**Village of Forest Park
Plan Commission Meeting Minutes
Monday, 02 March 2020**

Village of Forest Park Memorandum

SUBJECT: **PC 2020-03** 161 Harlem Ave.
Petitioner: Ampler Development represented by MRV Architects

DATE OF REPORT: 21 July 2020
DATE OF PLAN COMMISSION MEETING: 03 August 2020

LANDSCAPE PLAN

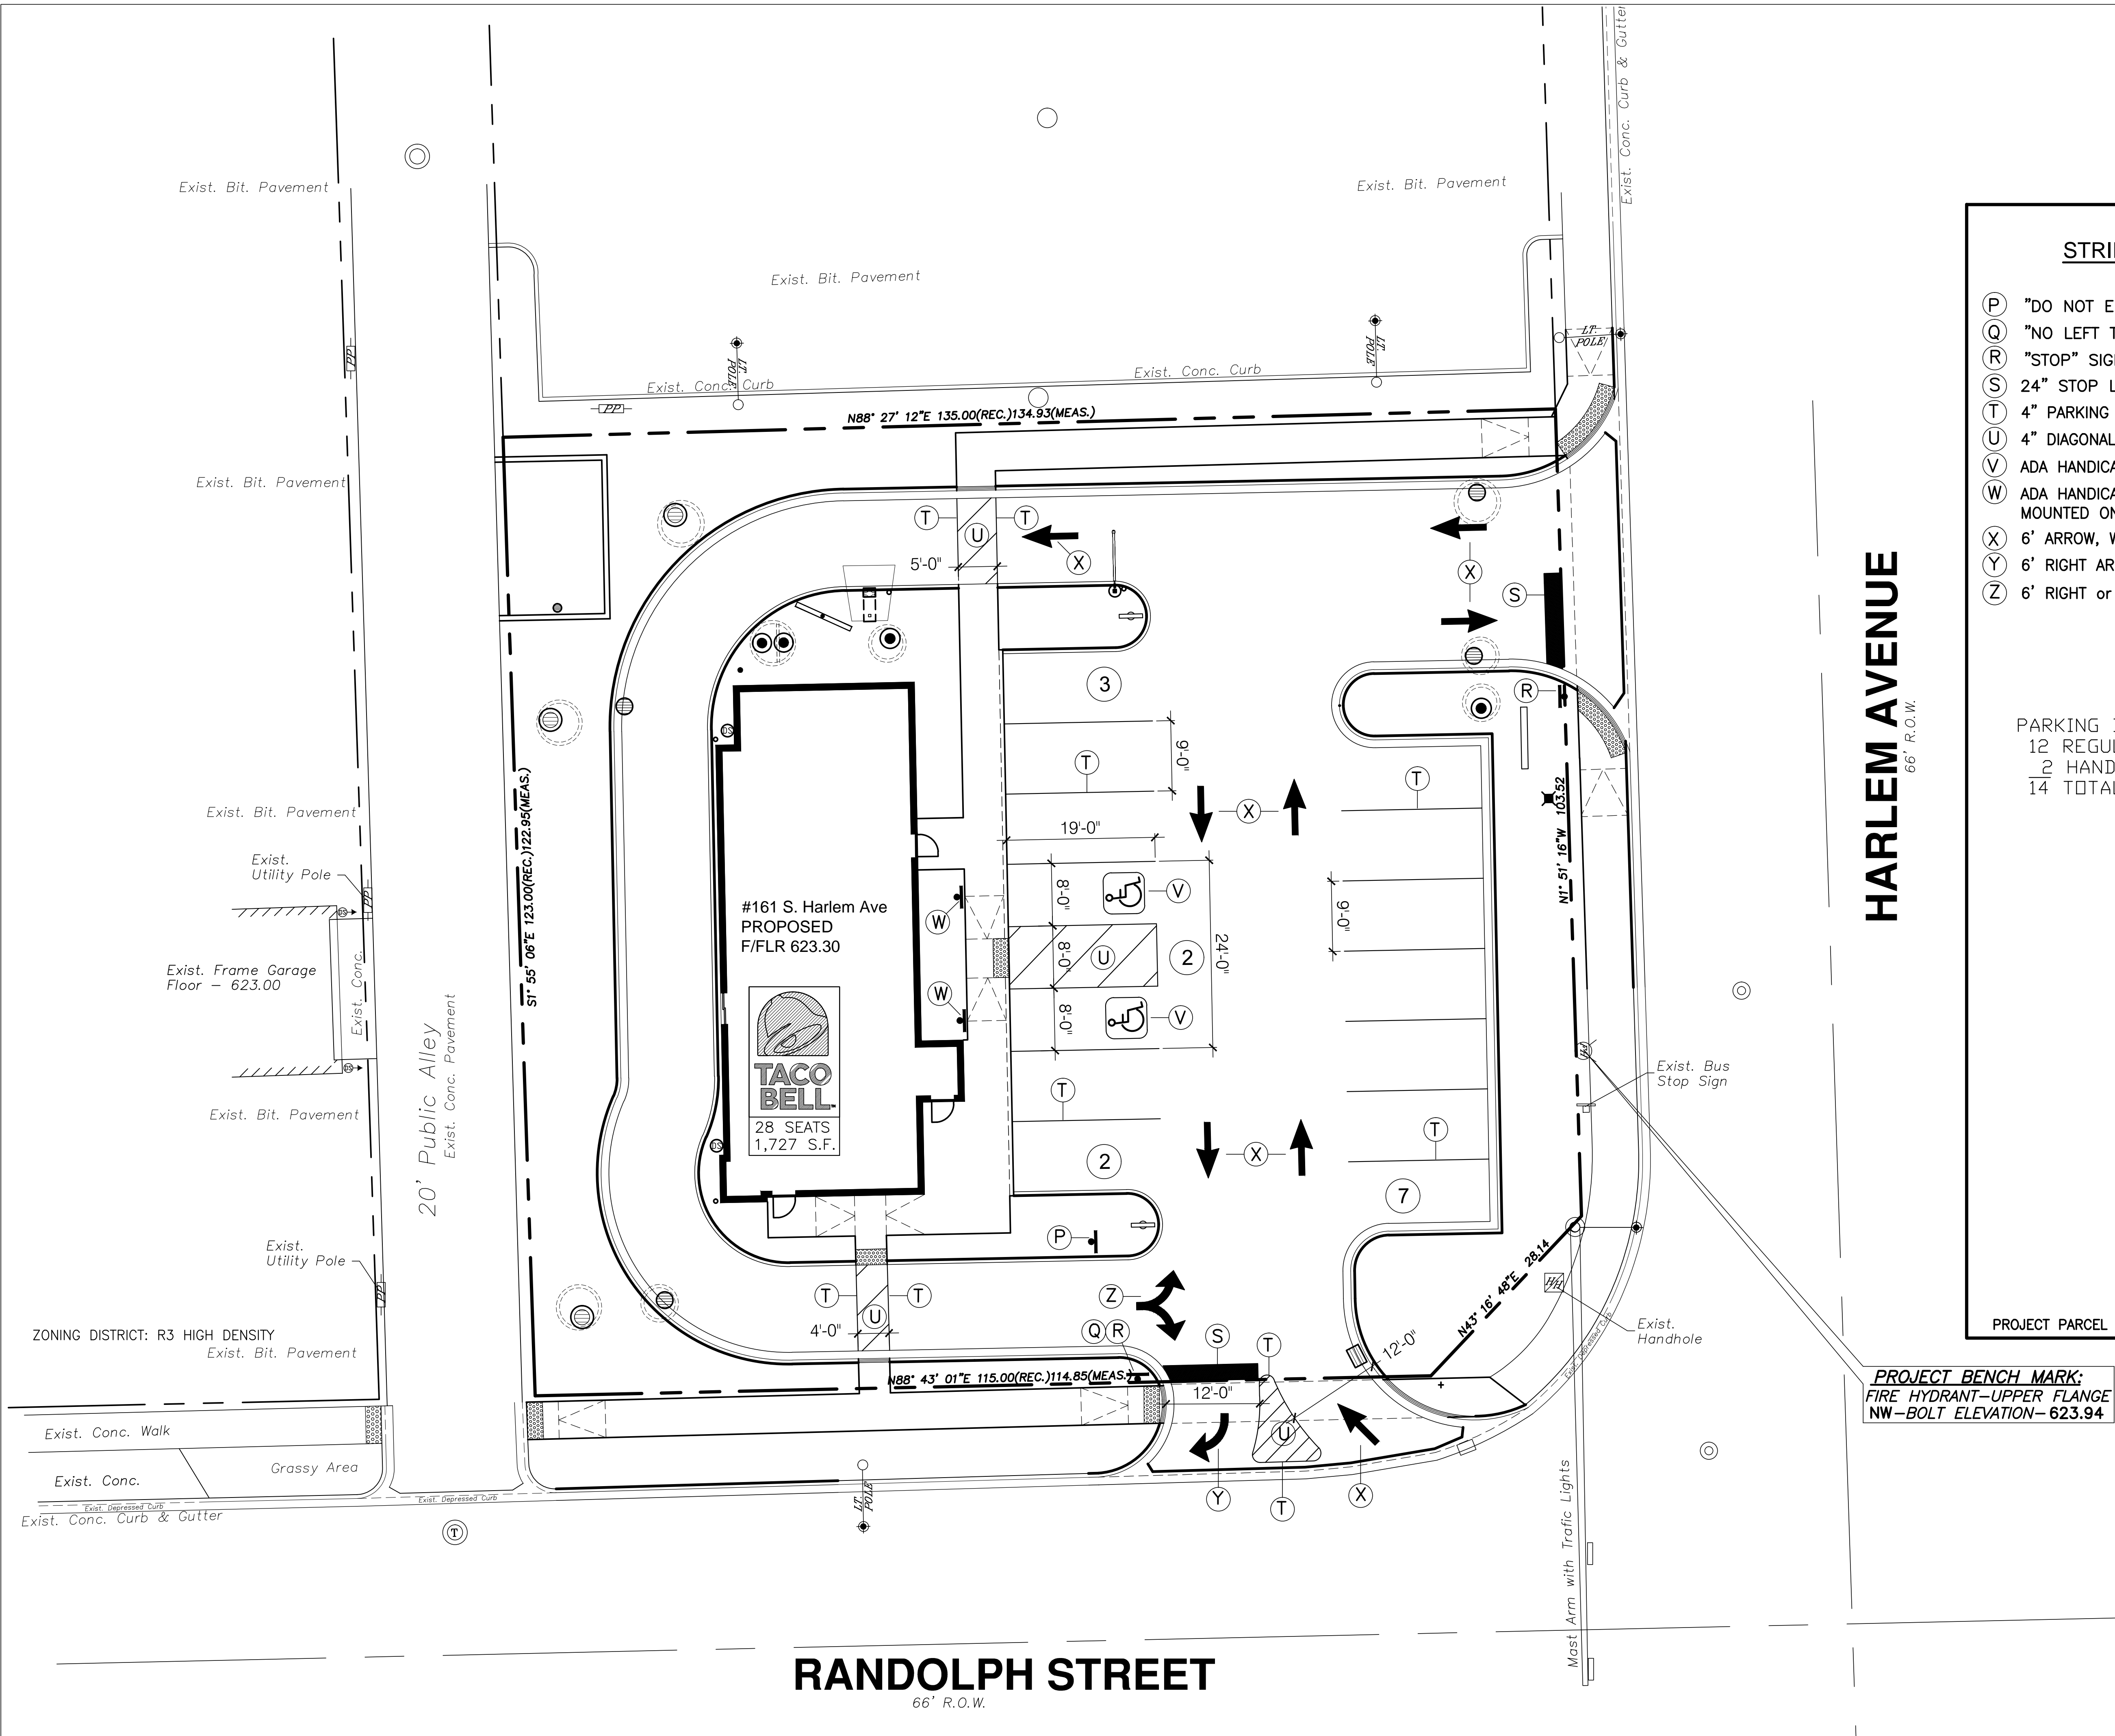
The site landscape plan has been reviewed and approved by staff and the Village Planner and is in keeping with the requirements of this section.

SITE PLAN 1" = 10' **1**

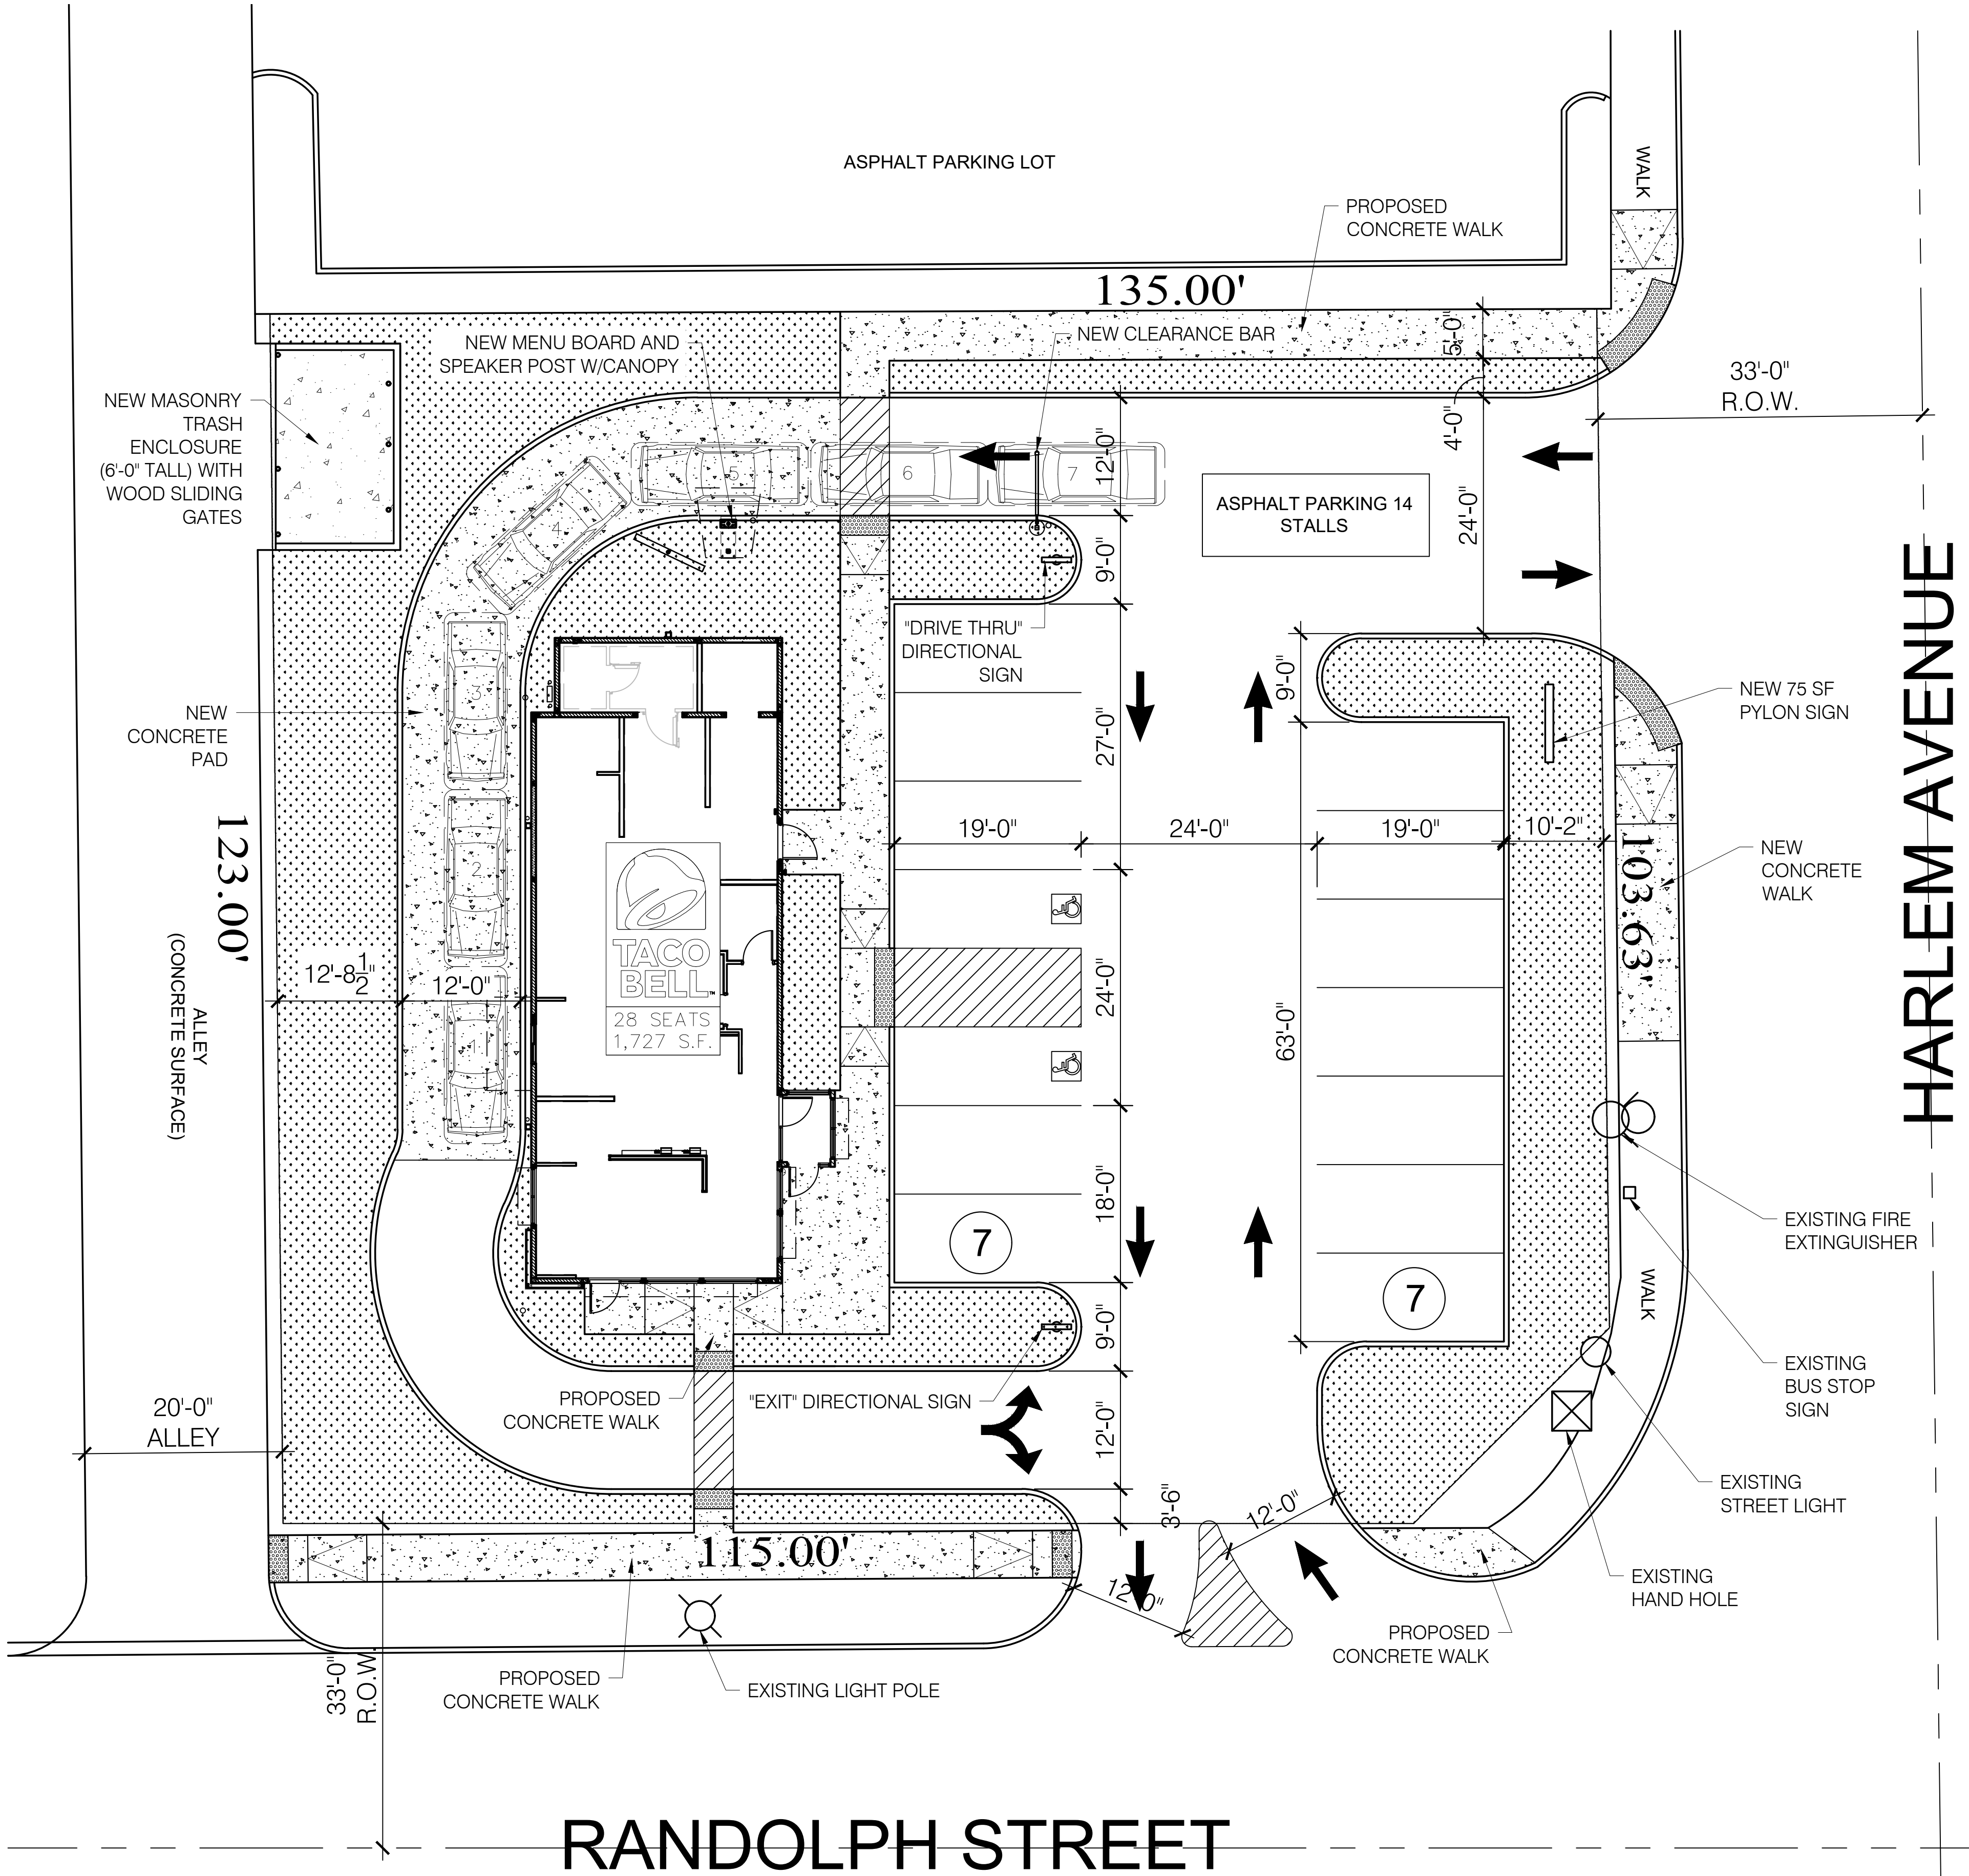
Traffic Access/Egress. As mentioned, this is an experienced developer who has provided staff with background and data supporting the design and anticipated site volume/capacity. Furthermore multiple 3rd party approvals serve as redundant mechanisms to ensure compliance both on site as well as access and egress. The ZBA has added as a condition of approval a demising fence along the alley frontage completely separating the subject property from the public alley.

Site Lighting. The site plan includes photometric plans designed to minimize over-illumination and are subject to review and approval of by both IDOT and the Village Engineer.
